How Does Carlson Support Their Users? Ask David Farina

Here is the original question from David Farina on March 4, 2009:

Time of Concentration (TR-55)

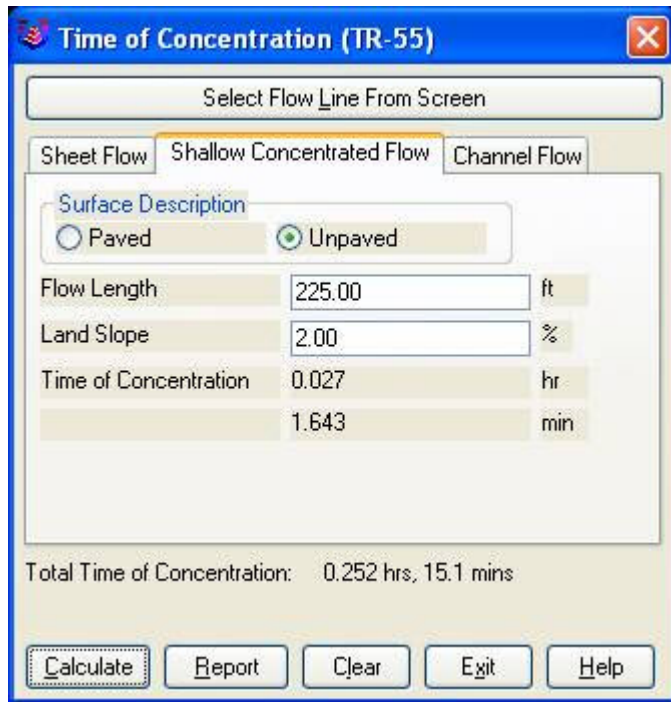
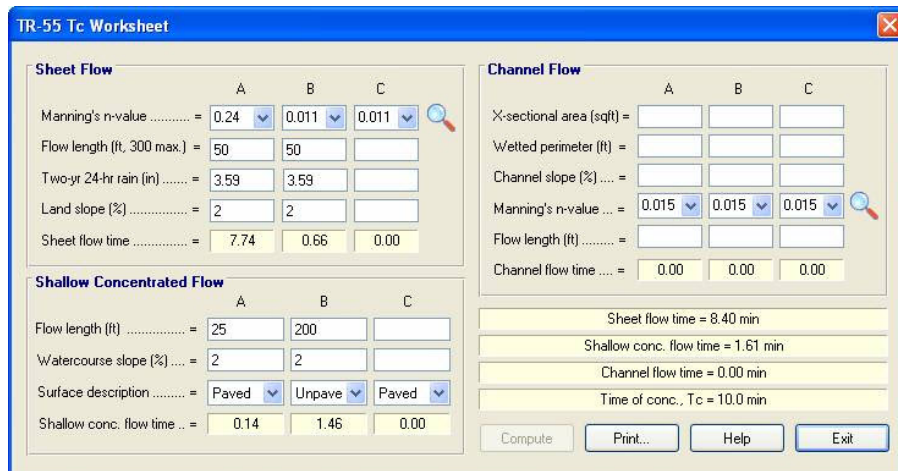
I was going through a mock project to learn the hydrology part of Carlson and noticed a critical deficiency in Time of Concentration input. The review agencies around here want to see the TR-55 method. First, the TR 55 minimum sheet flow needs to be 100' instead of 300'. They recently changed it per the TR-55 Web site. Second, I don't think I've ever had a project where you didn't have to split one of these flow types

into 2 or more manning's roughness areas.

For example: a flow path that starts on dense grass for 50' then passes over asphalt for 75' and back to grass for 200' would need to be calculated as follows:

Sheet flow 50' Grass -> Sheet flow 50' Asphalt -> Shallow Concentrated flow 25' Paved -> Shallow Concentrated flow 200' UnPaved.

But as you can see the Carlson input only allows for one entry per flow type.

Below is the Intellisolve version: Notice the A, B C

There is a 5.1 minute difference in TC results which results in a 2 CFS difference in the 100yr example below:

Here's an update to the Tc by TR-55 routine that allows unlimited number of breakouts. This update is for Carlson 2009 on Acad 2007-09. To install, unzip and copy the arx to the Carlson2009LSP folder. Let me know if you need a different version or have more suggestions.

Time of Concentration (SCS)

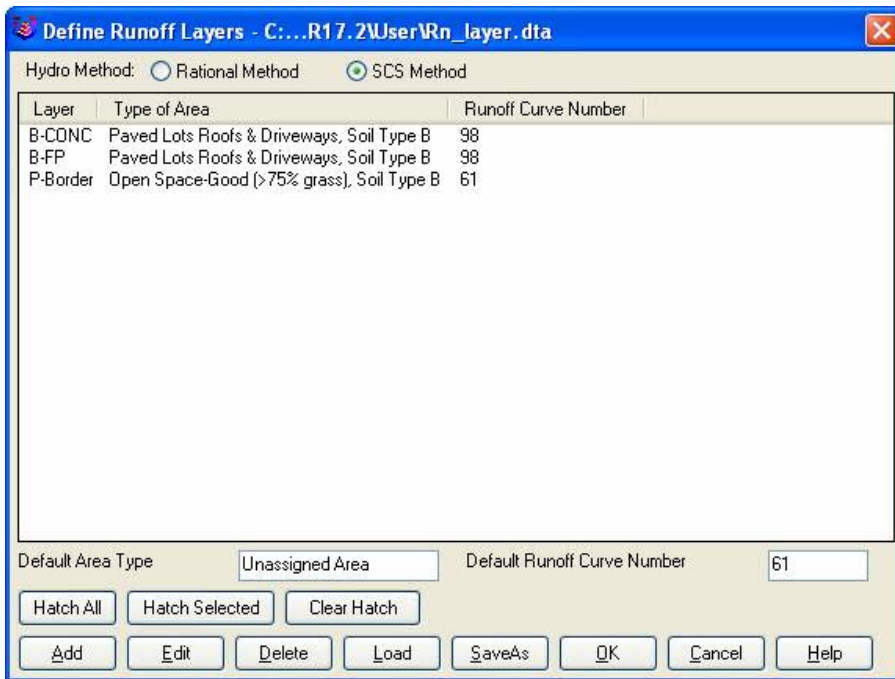
Was the SCS method used to get the 7.1 min value?

Notice the 7.5 value in the TC dialog to the right.

This was the value if I SELECT FLOW LINE FROM SCREEN and pick the path that the dialog on the left generates.

Can I generate a report of how the time to inlet was

calculated?

Maybe there can be a button next to the Time to inlet to select TR-55

Maybe Mannings coefficients can also be put into the WATERSHED->DEFINE RUNOFF LAYERS to be used for this calc as the flow path passes through each polyline area the same way Carlson already calculates the composite CN.

For the Storm Sewer Network routine, I put it on the to-do list to add a Select button next to the Tc to show the components that make up the Tc like the Select button does for CN. Also we will look at adding Manning's n to the Define Runoff Layers for use with Tc calcs.
